Service Bulletin No: 71-001

ATA Chapter: 71

**POWER PLANT - GENERAL
ONE-TIME INSPECTION FOR THE CORRECT INSTALLATION OF ATTACHMENT HARDWARE****1. Planning information****A. Effectivity**

LH/RH Middle inner nacelle - Inspection for loose nuts
Figure 1

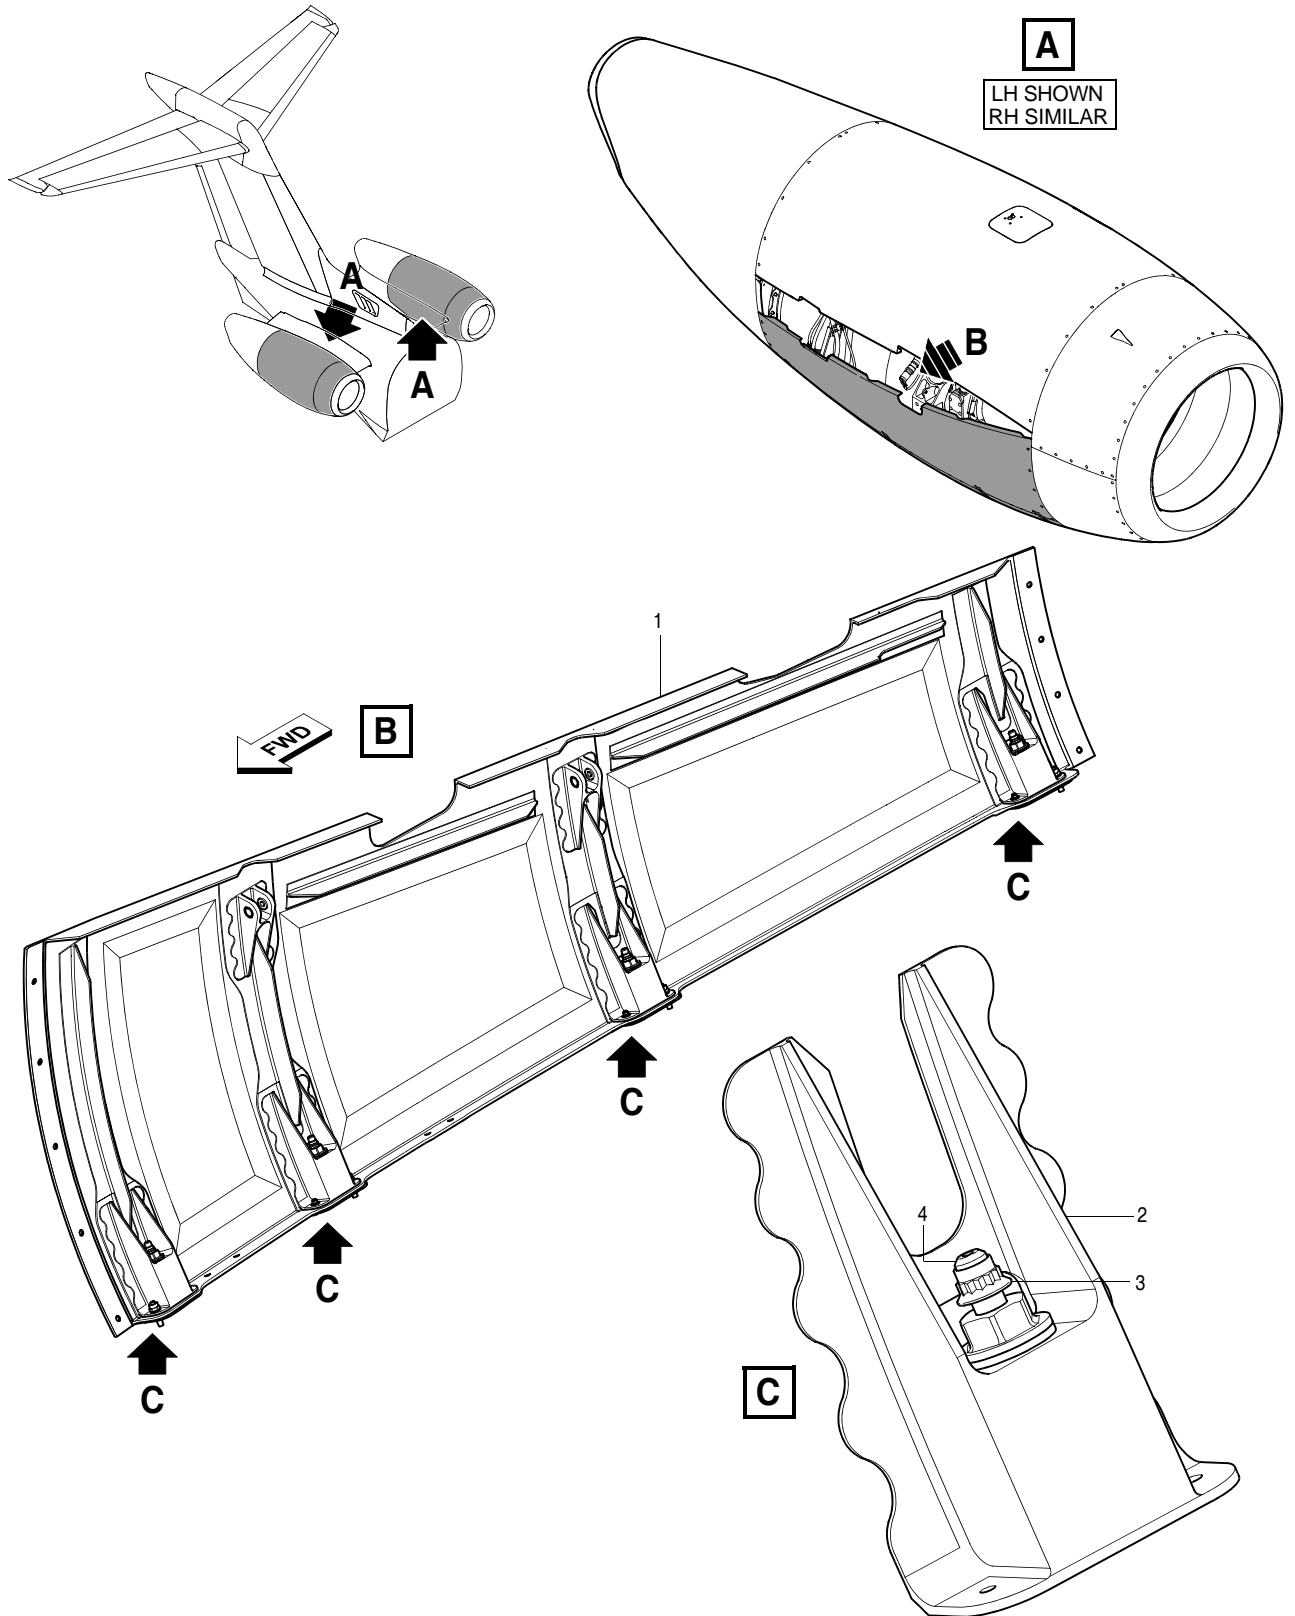
(1) LH/RH Middle inner nacelle. Refer to Figure 1

- (a) Do an inspection to determine if the nuts (3) are sufficiently tightened on the four keeper fitting (2) attachment bolts (4) on the middle inner nacelle (1). Refer to Figure 1 (View C).
- (b) If you find that a nut (3) is not sufficiently tightened:
 - 1 Correctly install the nut (3). Use a new nut (3) (P/N 938.09.14.204) if necessary.
 - 2 Torque the nut (3) plus the run-down torque. Refer to AMM PC24-A-E20-20-0001-00A-040A-A.
- (c) Do the above inspection procedure on the other side of the aircraft.

LH/RH Front and rear engine beams - Inspection for washer installation
Figure 2

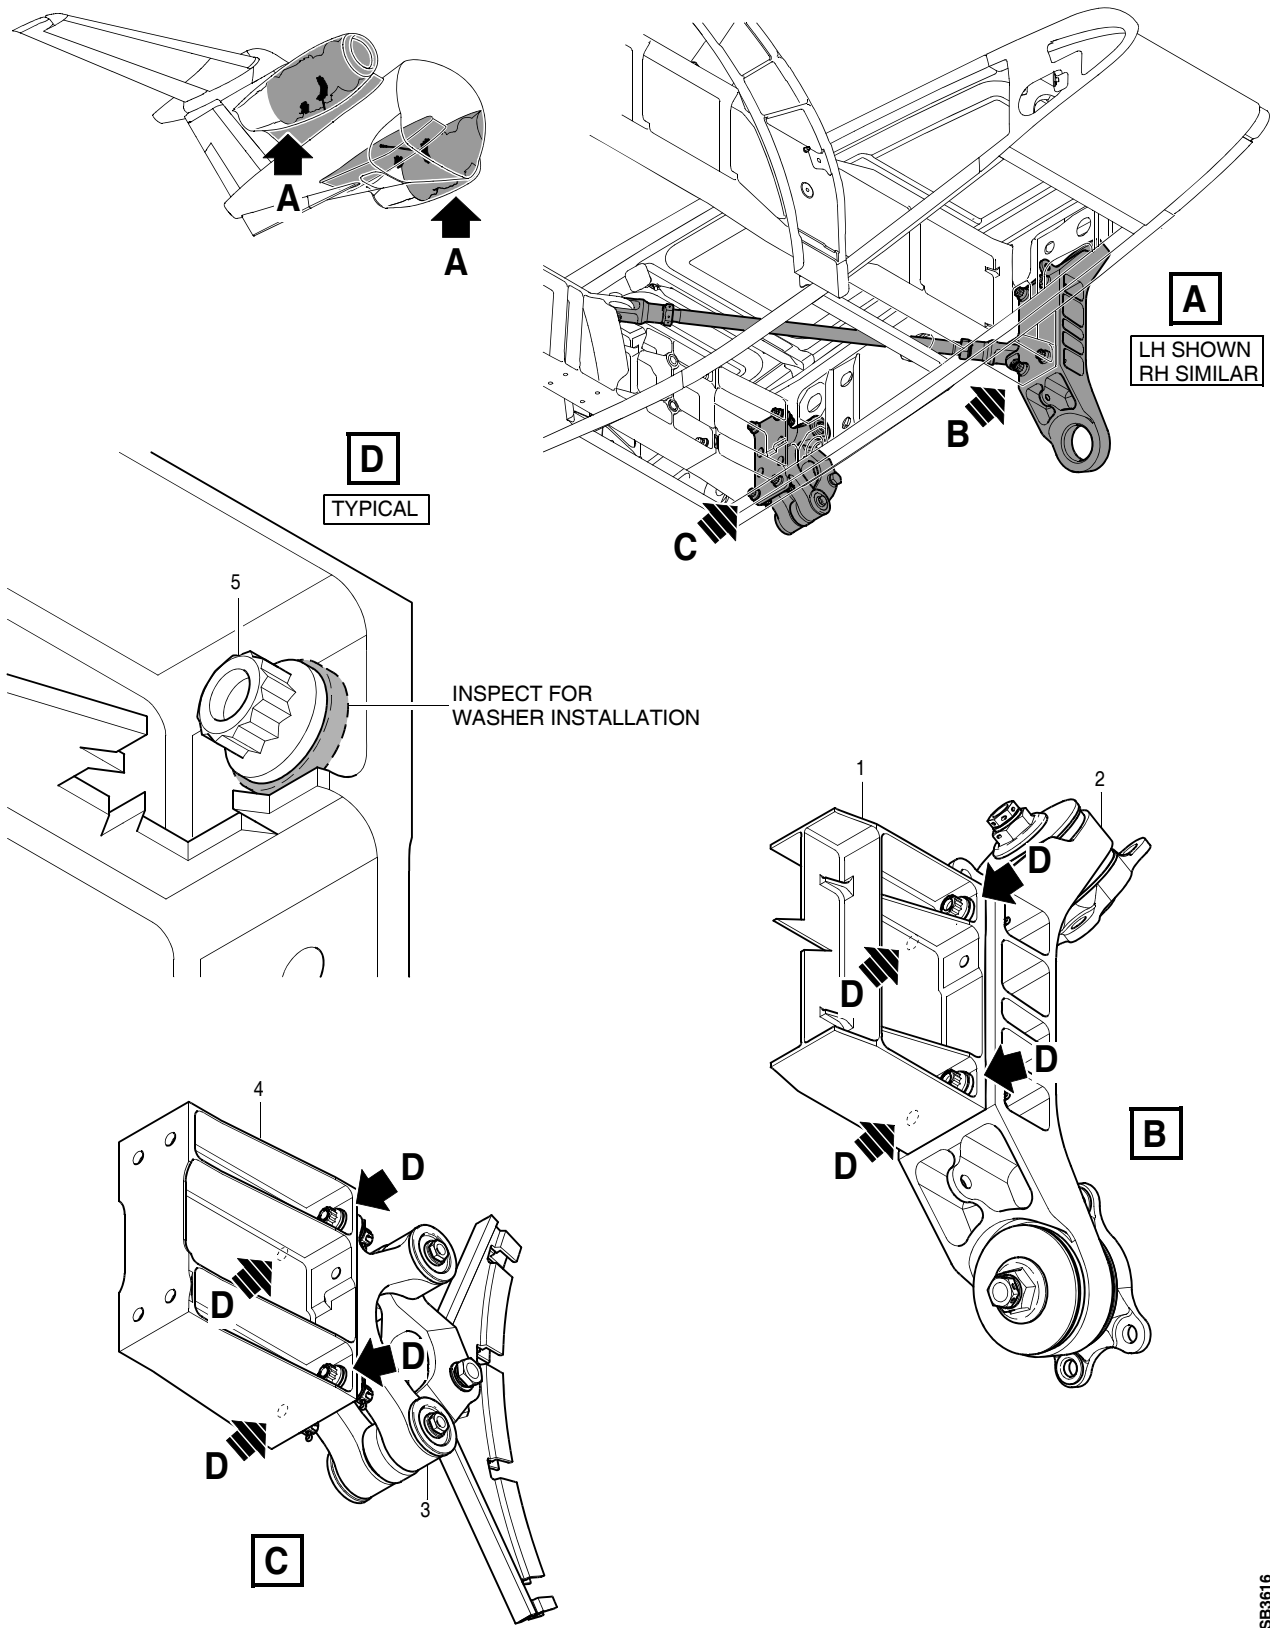
(2) LH/RH Front and rear engine beam. Refer to Figure 2

- (a) Do an inspection to determine if washers are installed below the bolt heads (5) at the:
 - Four attachment points of the front engine beam (1) to yoke (2). Refer to Figure 2 (View B and D)
 - Four attachment points of the rear engine beam plug (4) to aft isolator assembly (3). Refer to Figure 2 (View C and D).
- (b) Do the above inspection procedure on the other side of the aircraft.
- (c) If you find that washers are not installed, continue with this Service Bulletin from Para. **3.C.**
- (d) If you find that all of the washers are installed, continue with this Service Bulletin from Para. **3.D.**

LH/RH Front and rear engine beams - Installation of the washer
Figure 3

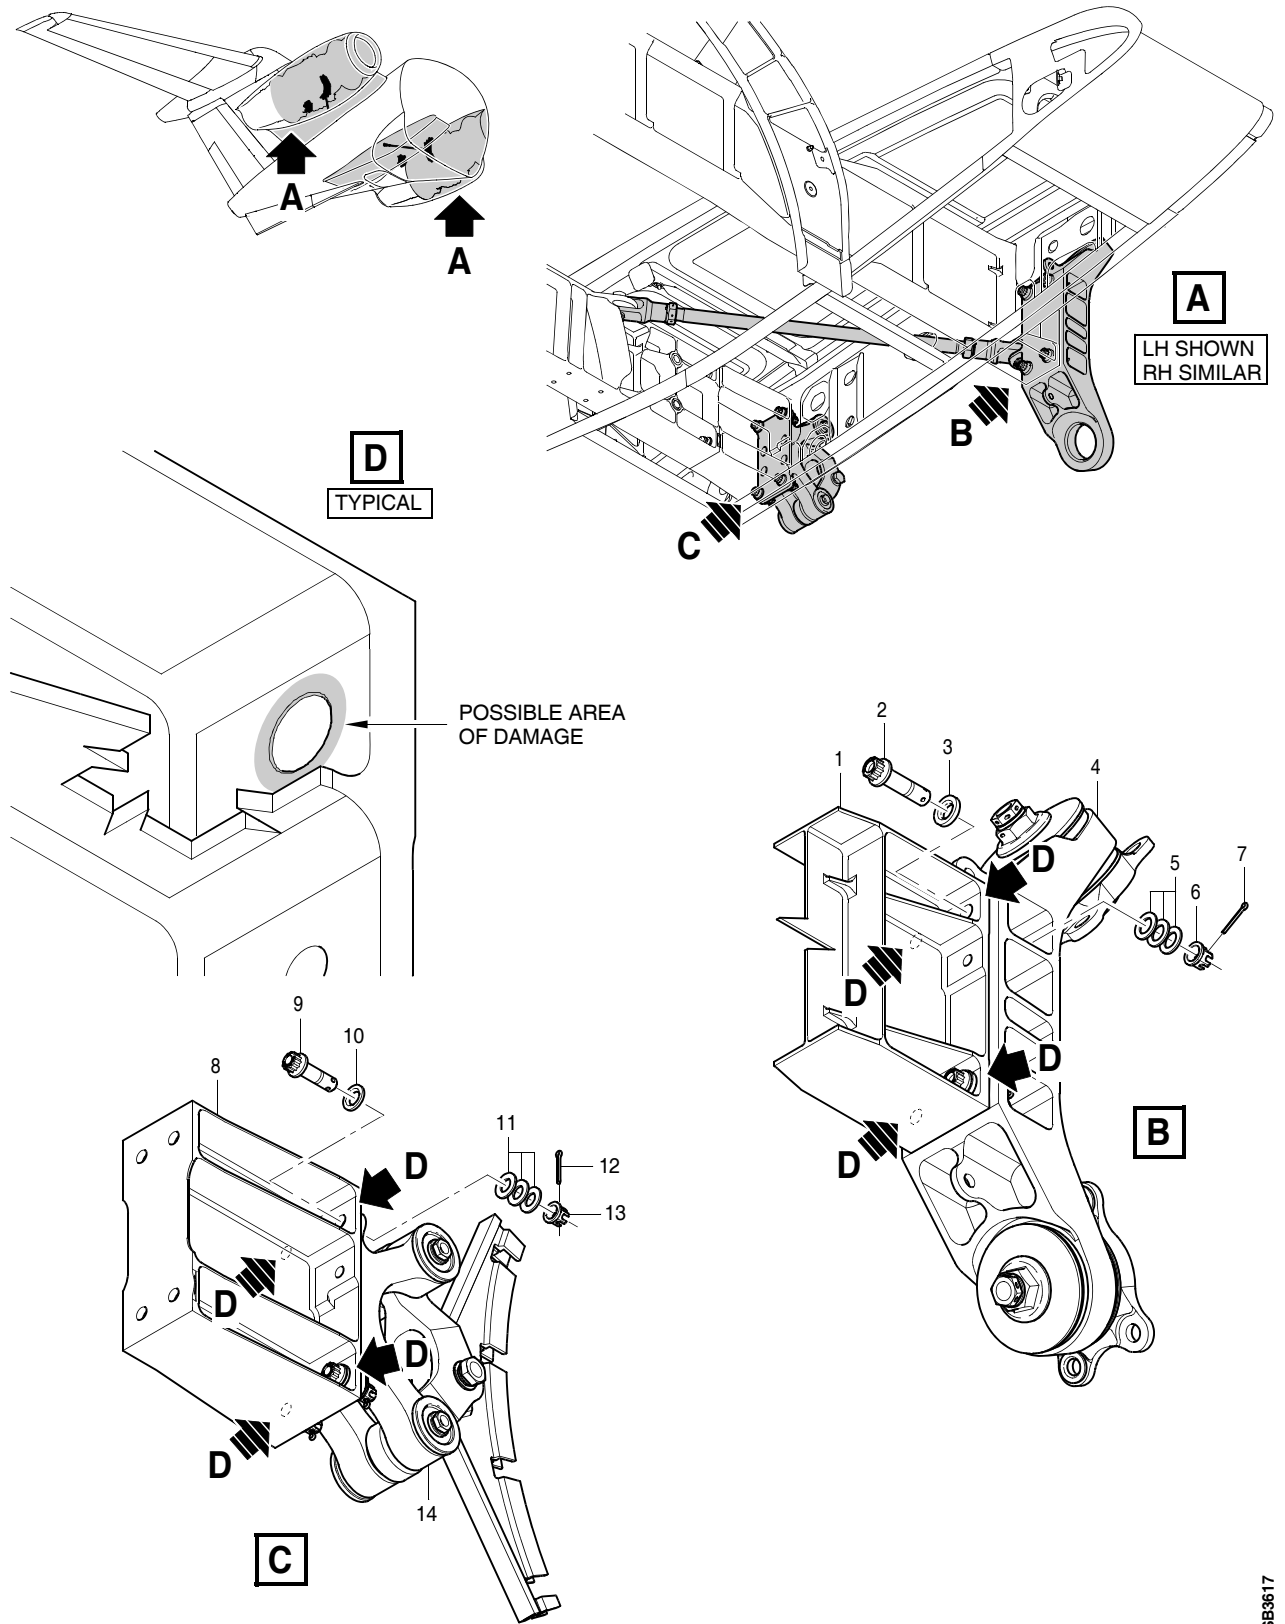
(2) Front engine beam to yoke attachment points. Refer to Figure 3

NOTE: Due to the bolt (P/N 571.20.24.010) being installed without a washer below the bolt head, the bolt must also be replaced.

**(3) Rear engine beam plug to aft isolator assembly attachment points.
Refer to Figure 3**

NOTE: Due to the bolt (P/N 571.20.24.005) being installed without a washer below the bolt head, the bolt must also be replaced.

- (a) Remove and discard the cotter pin (7).
- (b) Remove the castellated nut (6), the three washers (5) and the bolt (2) that attach the front engine beam (1) to the yoke (4). Discard the bolt (2).
- (c) Use a clean lint-free cleaning cloth (Material No. P02-041) made moist with solvent (Material No. P01-010) and clean the area around the bolt hole.

- (f) Loosely install a new washer (3) (P/N 571.20.24.009), the new bolt (2), the three washers (5) and the castellated nut (6). Use a new castellated nut (6) (P/N 560.20.99.012) if necessary.

- (g) Torque the castellated nut (6) to between 487 and 540 in-lb (55 and 61 Nm) plus the run-down torque. Refer to AMM PC24-A-E20-20-0001-00A-040A-A.
- (h) Safety the castellated nut (6) with a new cotter pin (7) (P/N 940.17.02.520).

- (c) Remove the castellated nut (13), the three washers (11) and the bolt (9) that attach the rear engine beam (8) to the aft isolator assembly (14). Discard the bolt (9).

- (g) Loosely install a new washer (10) (P/N 938.77.10.244), the new bolt (9), the three washers (11) and the castellated nut (13). Use a new castellated nut (13) (P/N 560.20.99.018) if necessary.

- (h) Torque the castellated nut (13) to between 194.7 and 256.7 in-lb (22 and 29 Nm) plus the run-down torque. Refer to AMM PC24-A-E20-20-0001-00A-040A-A.
- (i) Safety the castellated nut (13) with a new cotter pin (12) (P/N 940.17.02.520).
- (j) Do the above procedure again, as necessary, to install/replace a washer (10)/bolt (9) at any other applicable attachment point.
- (k) If removed, install the shut-off valve(s). Refer to AMM PC24-A-E36-10-0004-00A-720A-A.
